**Initial comments on the Ornithology Addendum  
for the  
Royal Society for the Protection of Birds**

**Submitted for Deadline 2  
11 November 2021**

**Application by Alternative Use Boston Projects Limited for an  
Order Granting Development Consent for the  
Boston Alternative Energy Facility**

**Planning Inspectorate Ref: EN010095  
Registration Identification Ref: 20028367**

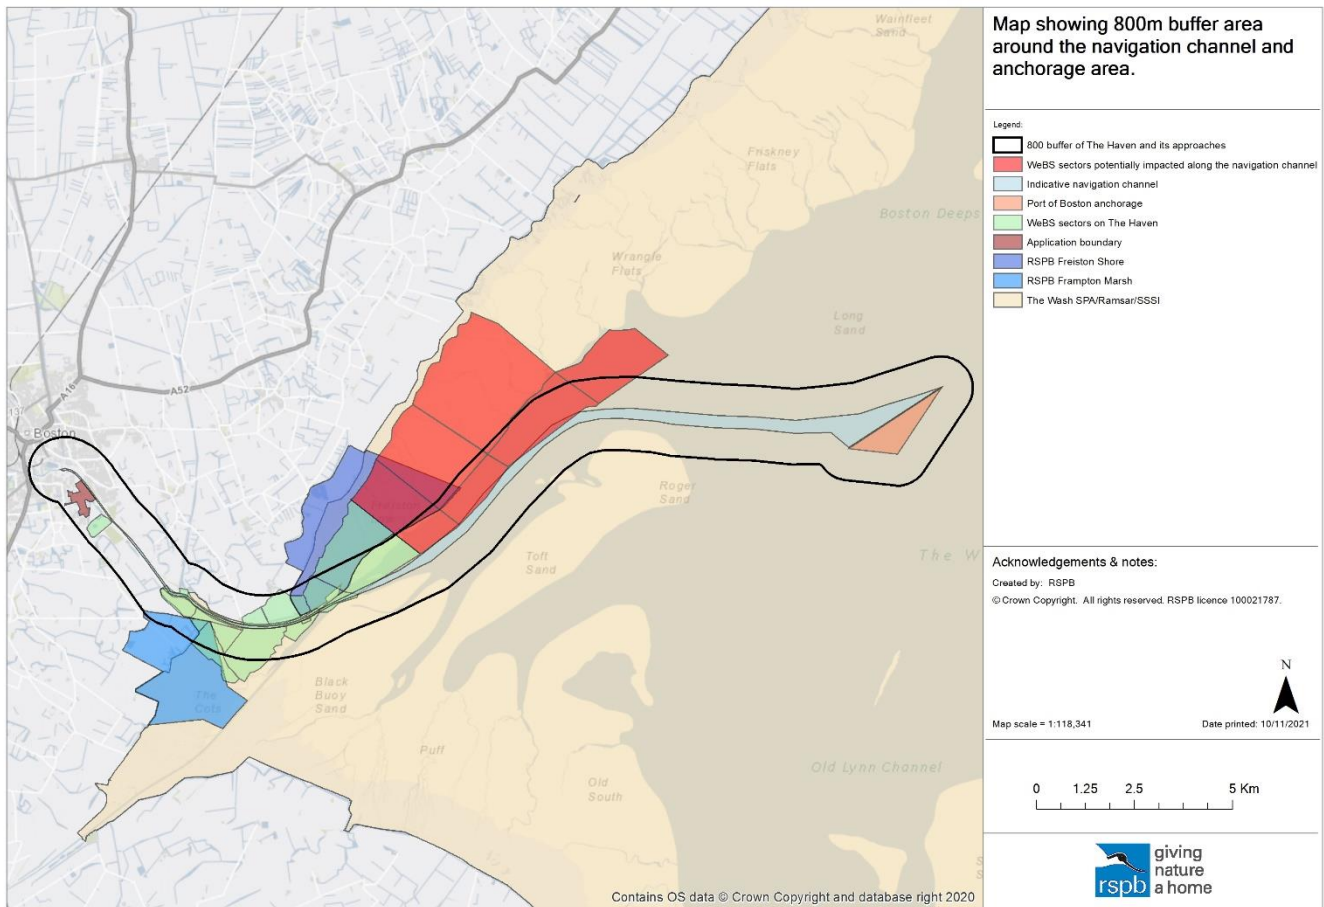
- 2.5 The Applicant's approach is one that suggests no disturbance could occur at any other point along The Haven or along the navigation channel out to the Port of Boston anchorage area. This is clearly an unrealistic scenario. Vessels have been shown to create disturbance to waterbirds as they approach The Haven from the anchorage area and along the navigation channel, as demonstrated by the Applicant's surveys. This disturbance will continue along the whole of The Haven as the vessels travel to the application site. However, no data has been collected by the Applicant to inform the actual abundance of these features along the navigation channel from the anchorage area to The Haven, their distribution, whether there are particularly important feeding and roosting locations, or any data on the effect of vessel movements along the navigation channel from the anchorage area to The Haven.

- 2.6 The Applicant's own data has shown disturbance from vessels as they approach the application site, with even small vessels having a greater impact than observed at the wider approaches to The Haven. The Applicant's own surveys have also recorded qualifying features of The Wash SPA/Ramsar that includes ringed plovers, dunlins, lapwings, turnstones, redshanks, oystercatchers, black-tailed godwits, bar-tailed godwits, curlews, grey plovers, cormorants, mallards, shelducks, black-headed gulls, herring gulls, lesser black-backed gulls and great black-backed gulls. This all provides evidence that these features are using The Haven. However, no data has been collected by the Applicant to inform the actual abundance of these features using The Haven, their distribution, whether there are particularly important feeding and roosting locations, or any data on the effect of vessel movements along The Haven.

- 2.7 Consequently, the potential area affected by the application is much greater than currently stated within the addendum and its appendix. Figure 1 shows the anchorage area and the navigation channel, with an 800m buffer. The Applicant's surveys have shown that birds may be displaced even further, with observations of up to 1000m on The Haven and 3300m from the mouth of The Haven. Whilst displacement distances inland from the navigation channel may be less, there is no data available to confirm this to be the case at this time. We consider such an area is needed to be considered in the HRA to ensure the full impacts of the application qualifying features of The Wash SPA/Ramsar are assessed.

- 3.11 This is an unrealistic approach as vessel movements occur along the whole of the navigation channel and as such will cause disturbance to waterbirds along the entire route. Whilst the actual scale of disturbance will vary from species to species, seasonally and even spatially along the navigation channel, no evidence has been collected to demonstrate an understanding of how qualifying features of The Wash SPA/Ramsar use The Haven and the navigation channel out to the anchorage area. A greater area should be used for the impact assessment such as that shown in Figure 1.

Figure 2: Map showing the area along The Haven where no existing data is known to exist on abundance and distribution of qualifying features of The Wash SPA/Ramsar. No data have been collected by the Applicant to determine waterbird abundance and distribution within this area.

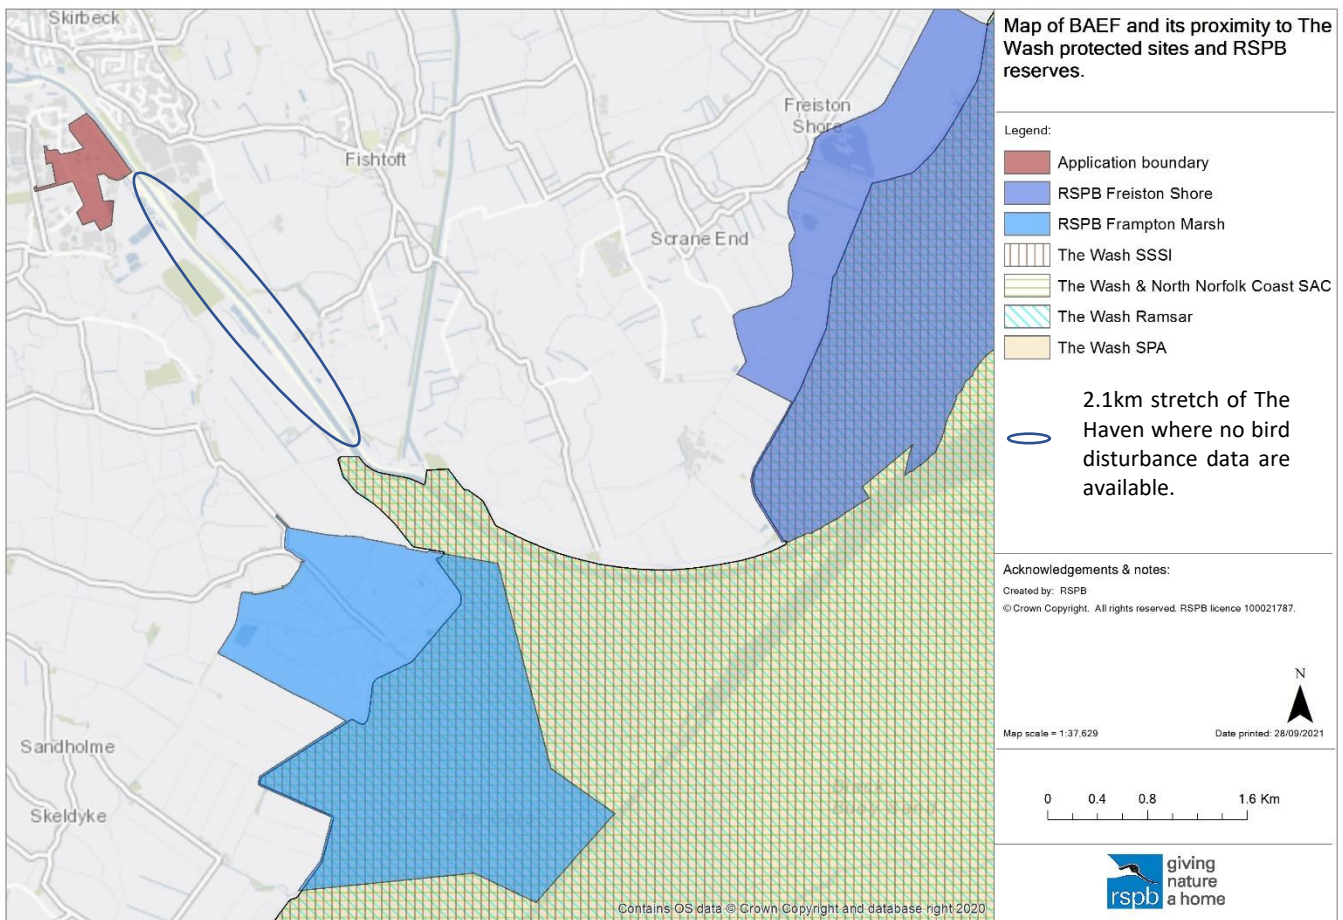
2.8 The Applicant has undertaken some limited ornithological surveys around the Application site and the mouth of The Haven. Whilst the Applicant has limited data for the area around the Application site, the mouth of The Haven, and now has WeBS data for the lower reaches of The Haven from Hobhole, there are no data available for a c.2.1km section of The Haven (Figure 2). Such data are needed to understand the full importance of The Haven for qualifying features of The Wash SPA/Ramsar/SSSI that will be foraging or roosting either within the channel or on adjacent banks. Disturbance from vessel movements will not just be confined to the areas for which data are available but continue along the whole of The Haven.

2.9 In addition, any surveys have focussed solely on the vessel movements along The Haven. There have been no assessments of recreational pressure or other activities that could be causing disturbance along The Haven. This is important to enable a full understanding of the cumulative and in combination pressure occurring as part of the baseline evidence. This additional information would help to identify:

Figure 3: Map showing the location of behaviour surveys undertaken at Tabs Head looking out onto The Wash. The viewshed for surveyor is provided to show the limited area of the lower reaches of The Haven and the navigation channel that they will have been able to observe during the surveys.

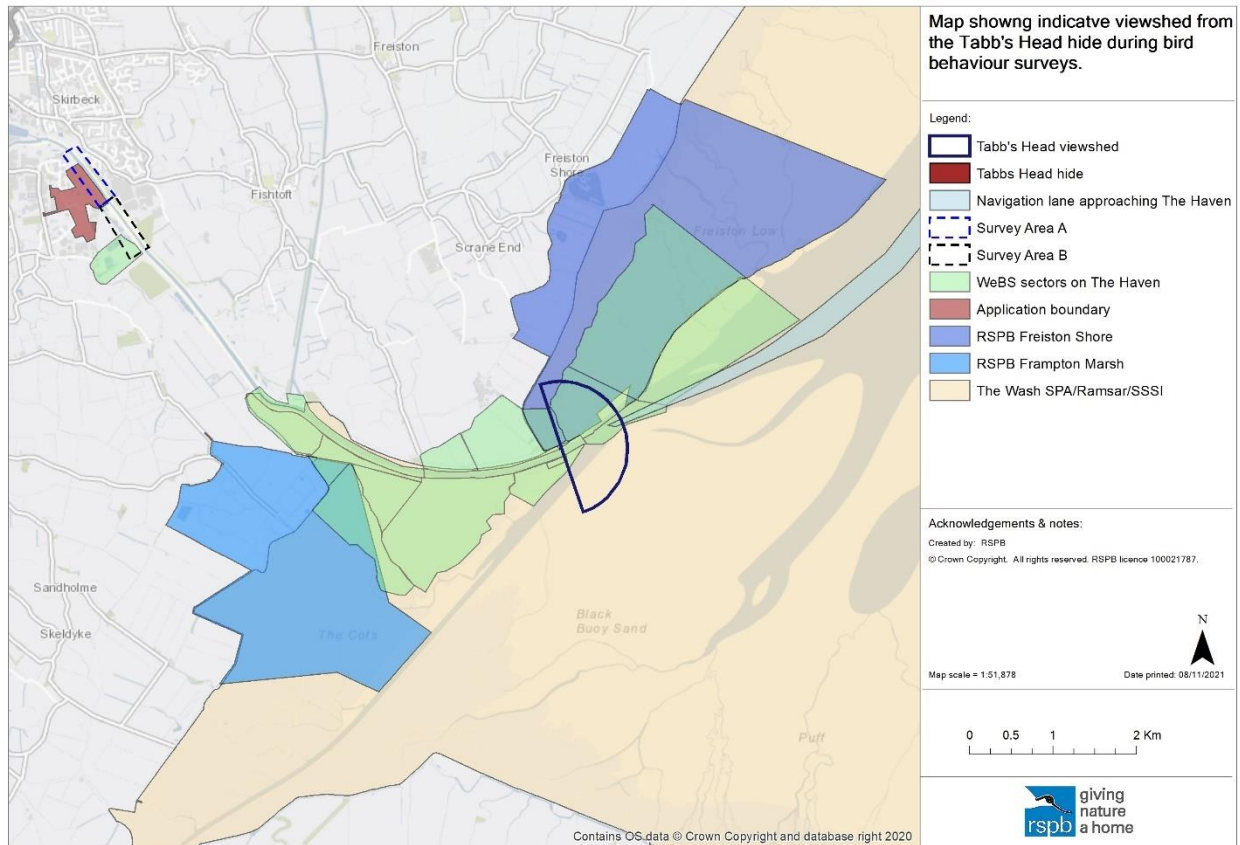
2.11 The surveys conducted at the mouth of The Haven have provided a helpful insight into the species that are present and their behaviour around the vessels using the channel. They demonstrate that the area is important for qualifying features of The Wash SPA/Ramsar and that disturbance occurs from the current vessel movements. However, we do not consider that they provide a full data set for assessing the impact of disturbance.

2.12 A specific limitation is that the surveys were conducted looking out onto The Wash from the hide at Tabs Head (Figure 3). This gives a 180° view onto The Wash. However, this does not allow for observations of vessel movements to be observed along The Haven. This is compounded by having only one surveyor carrying out the observations, as additional surveyors would be required to make observations in front and behind the hide. This means that the area of The Wash SPA/Ramsar up to Hobhole could not be observed during these surveys.

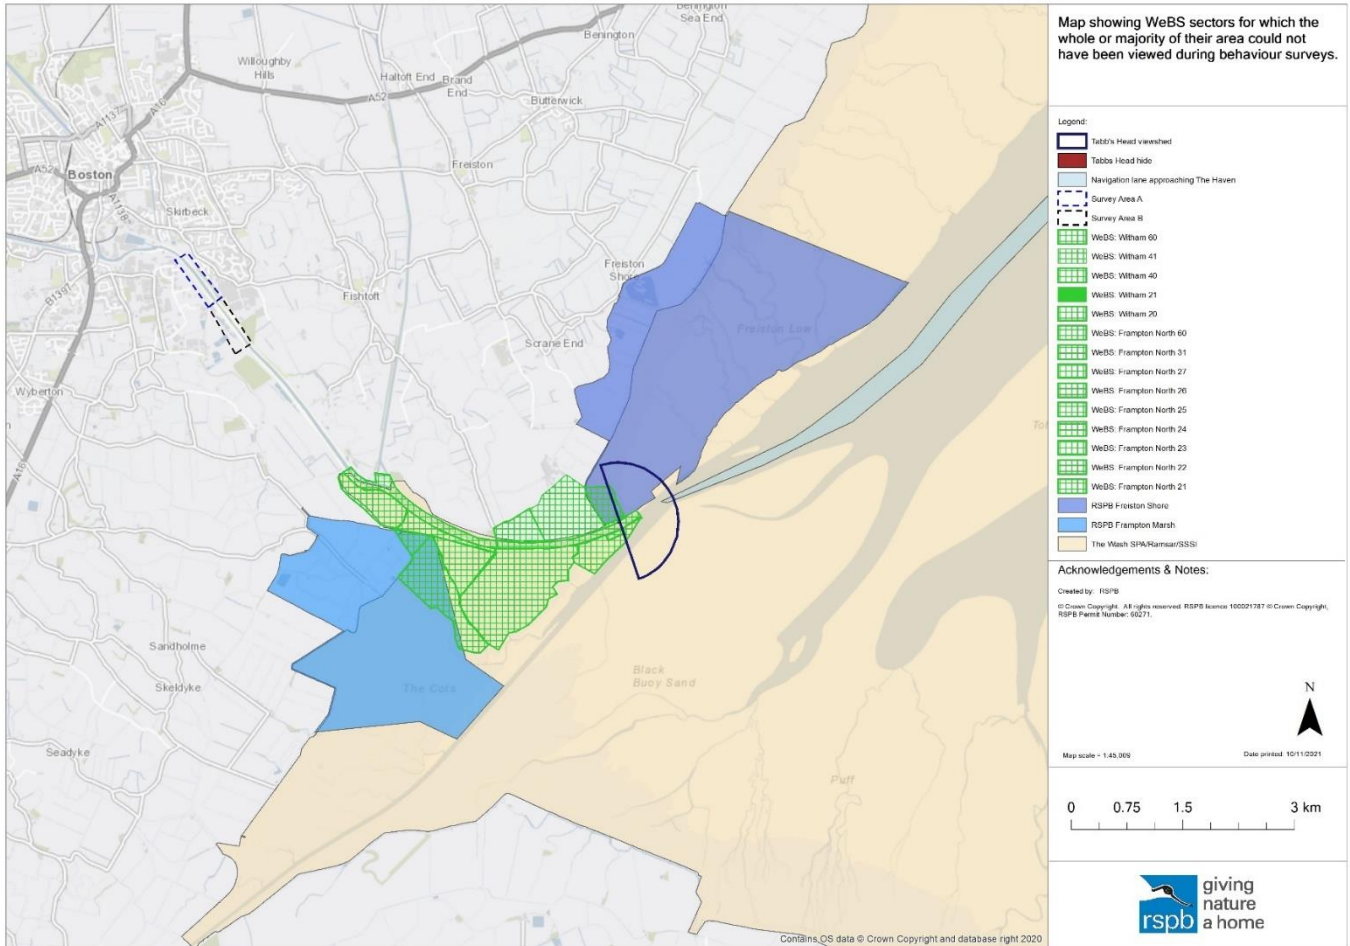
2.13 These are fundamental concerns with the survey approach given the number of sectors that support significant numbers of qualifying features of The Wash SPA/Ramsar, yet no data have been collected to understand the disturbance effect from vessels using the navigation channel through and past these sectors (Figure 4). Whilst the surveys provide useful information, they cannot provide a complete understanding of the effect of vessel movements on qualifying features of The Wash SPA/Ramsar. This is essential to ensure that all areas that could support qualifying features of The Wash SPA/Ramsar are fully understood to know where features roost and forage, the pressures that

they face along The Haven and out into The Wash, and how they respond to vessels and other disturbance pressures. It will not be possible to draw robust conclusions in the HRA where such evidence does not exist.

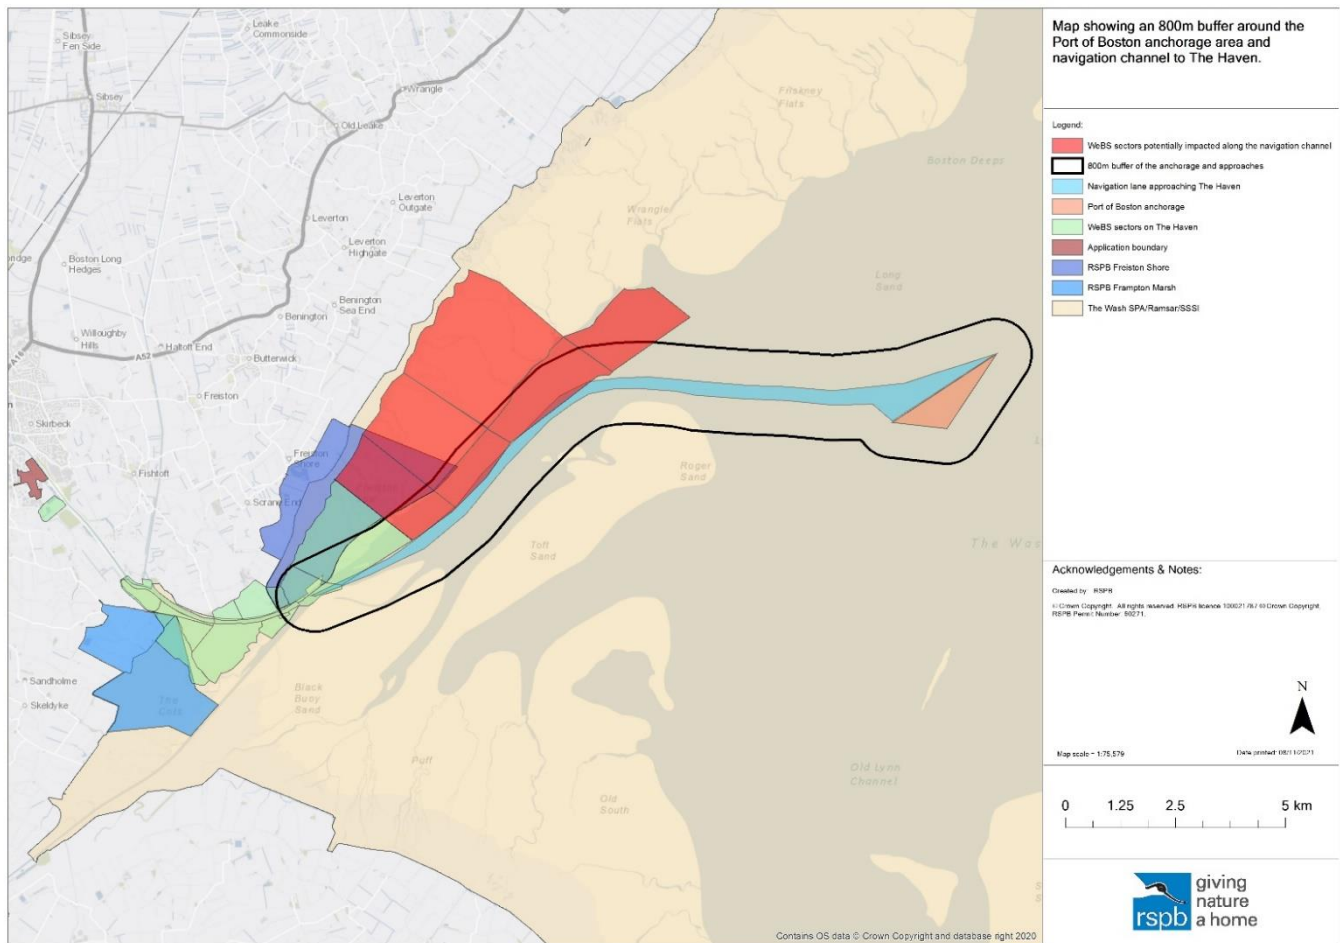
2.14 In our Written Representations, we have identified that there is a lack of data to identify the baseline disturbance levels to qualifying features of The Wash SPA/Ramsar around the Port of Boston anchorage area and the approaches to The Haven. The surveys conducted to date have only observed behaviour changes in waterbirds a relatively small area close to the mouth of The Haven. Figure 5 shows the indicative area of the anchorage area and the navigation channel used by vessels accessing or leaving The Haven. We have buffered it by 800m to be consistent with the observed displacement of birds at the mouth of The Haven to show the extent of the area for which no baseline data exists to rigorously assess the impact that current levels of vessel movements have within The Haven. This is important to assess the current impact that this activity is having on the abundance and distribution of qualifying features of The Wash SPA/Ramsar.

2.15 Figure 5 also identifies that there are additional WeBS sectors along the navigation channel leading to the anchorage area that could be impacted by disturbance from vessel movements. We recommend that the data for these additional WeBS sectors be obtained and included in revised assessments of potential impacts both of baseline activity and during construction and operation of the facility. The Sectors that need to be included are:

- Butterwick 30
- Butterwick 51
- Butterwick 31
- Butterwick 52
- Benington 30
- Benington 50
- Leverton 50
